CITY OF ALBUQUERQUE

**RE: Lot 12 Block 2 Unit 19 Volcano Cliffs SAD 228
6520 Camino Del Oeste NW
Grading and Drainage Plan
Engineers Stamp Date 4/11/17 (D10D003G12)
Pad Certification Dated 6/2/17**

Based upon the information provided in your submittal received 6/7/17, this plan is approved for Building Permit.

| | GRADING AND DRAINAGE PLAN | DATE 4-10-17 |

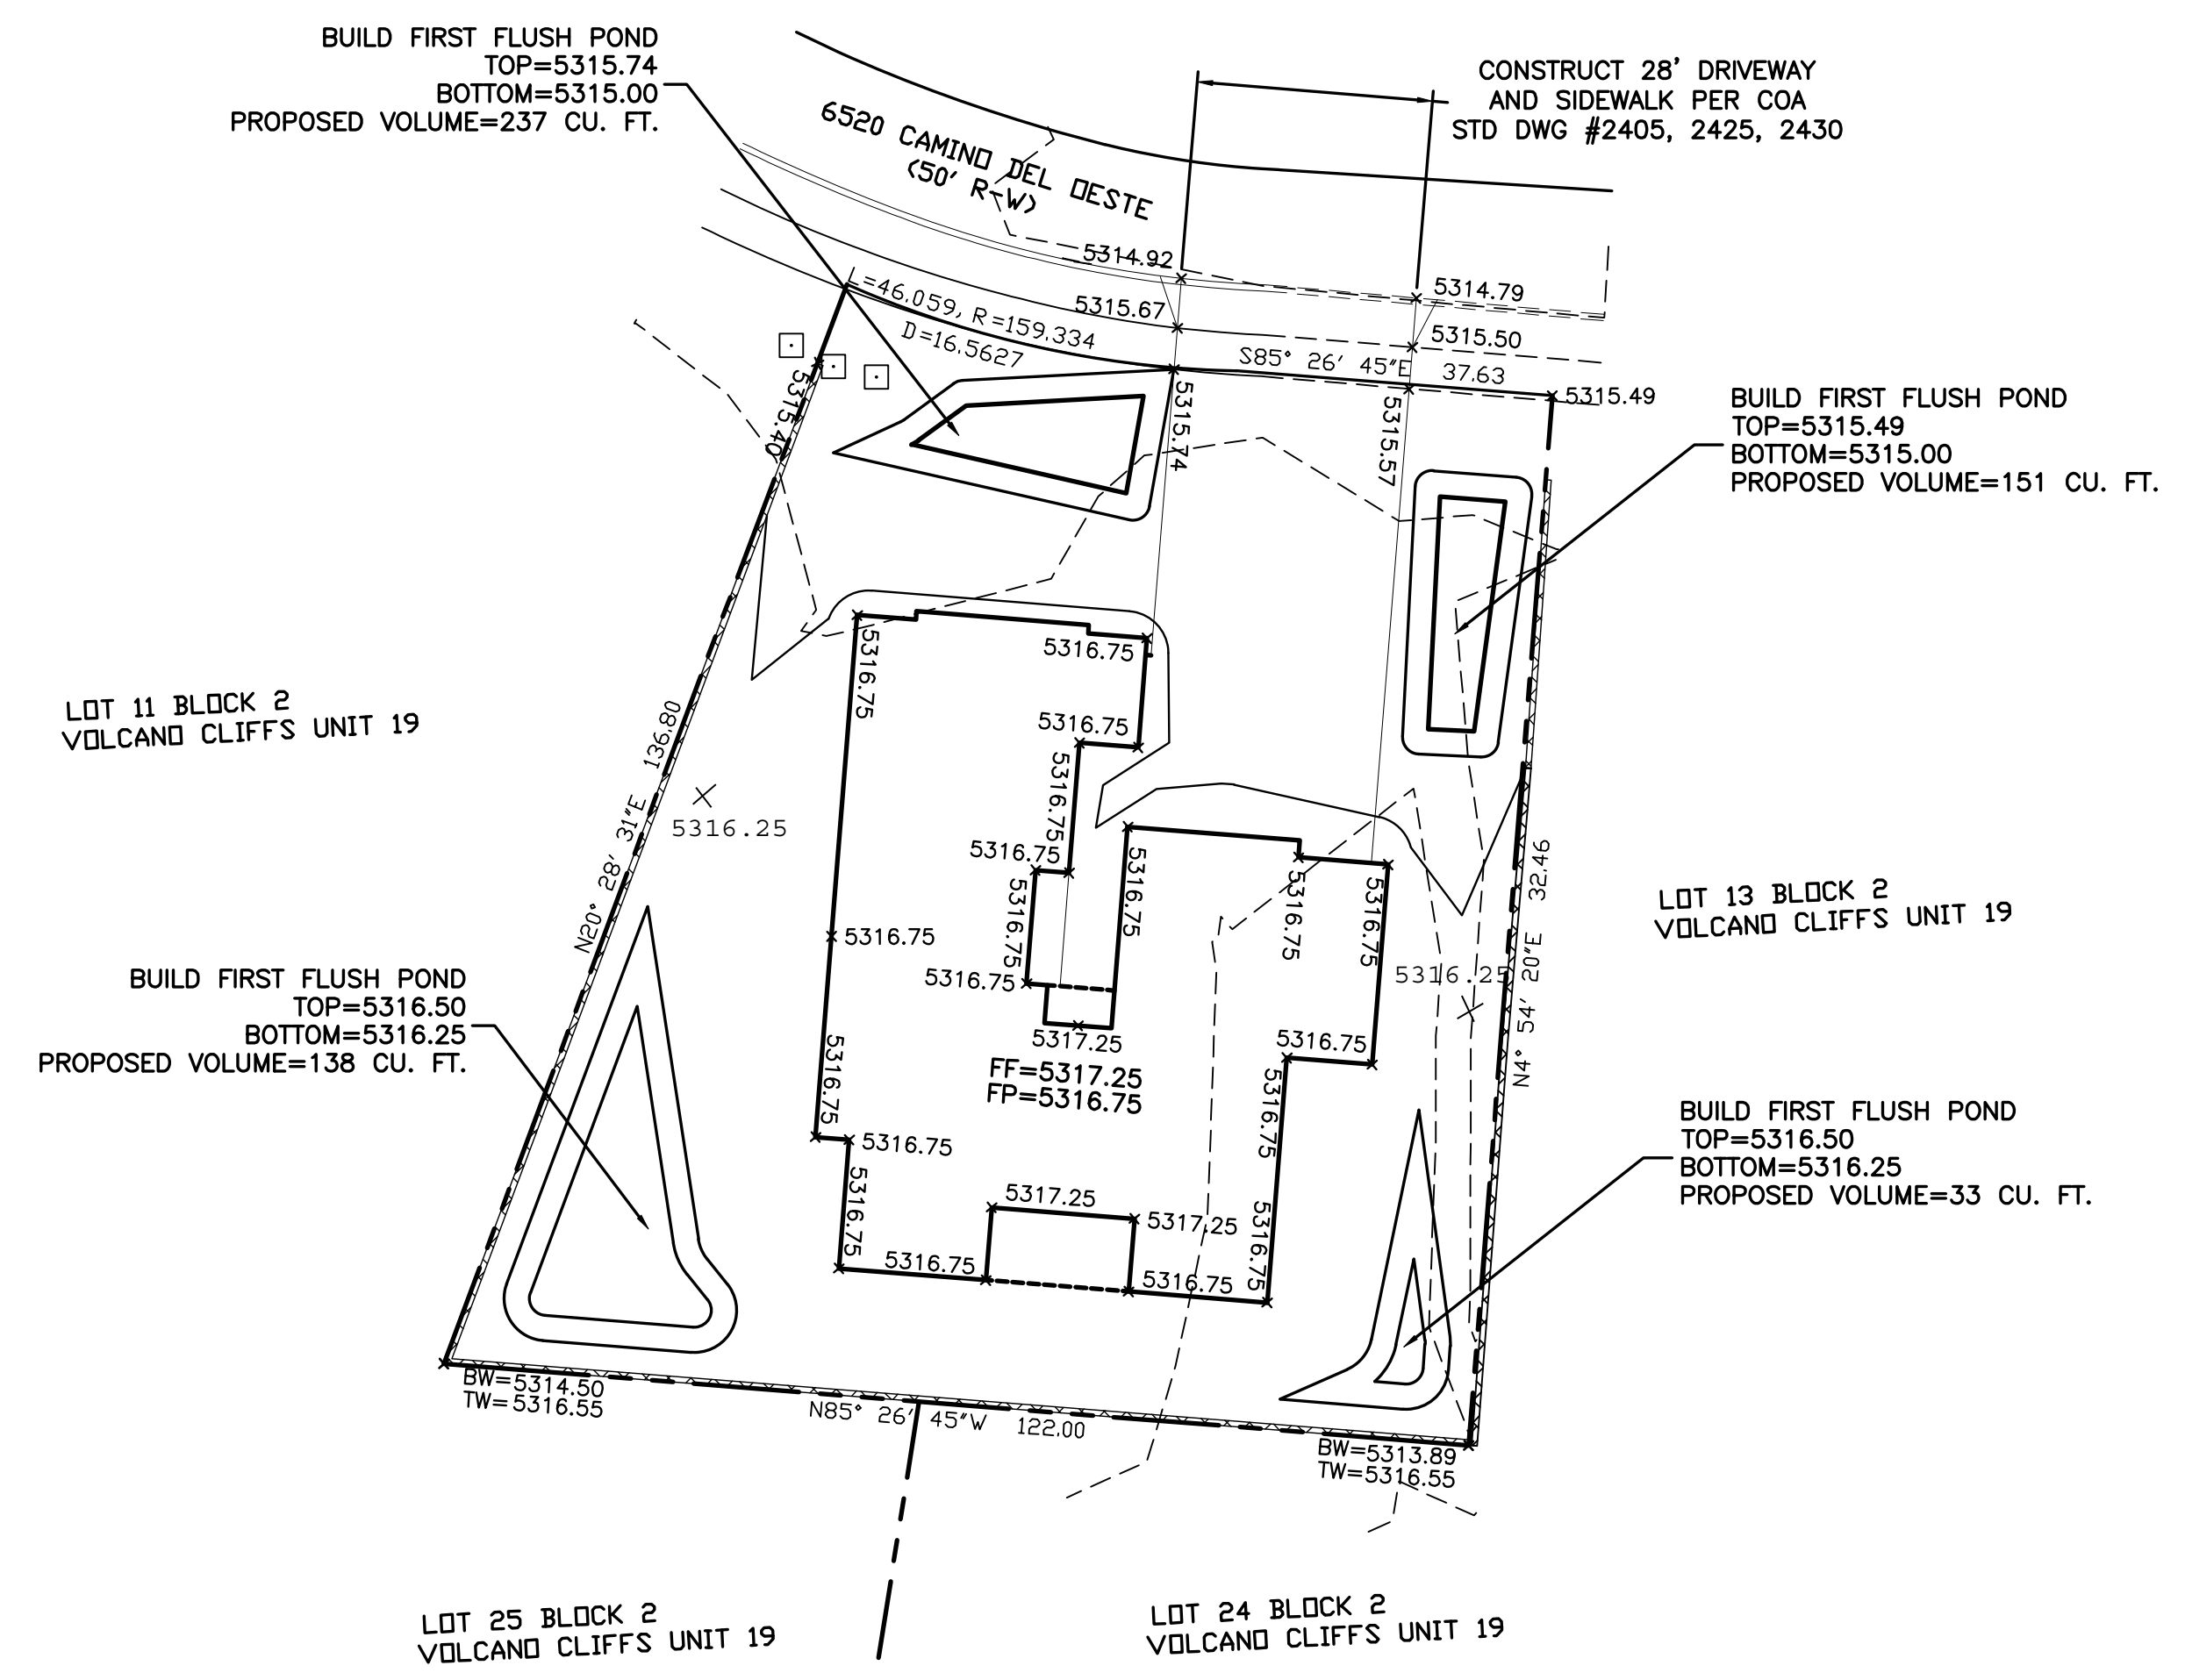
Please inform the builder to attach a copy of this approved plan to the construction sets in the permitting process prior to sign-off by Hydrology. Also, notify the owner/contractor that a separate permit for any fence is required, and this is the plan to be used for the placement of the fence.

Prior to Certificate of Occupancy release, Engineer Certification per the DPM checklist of this plan will be required.
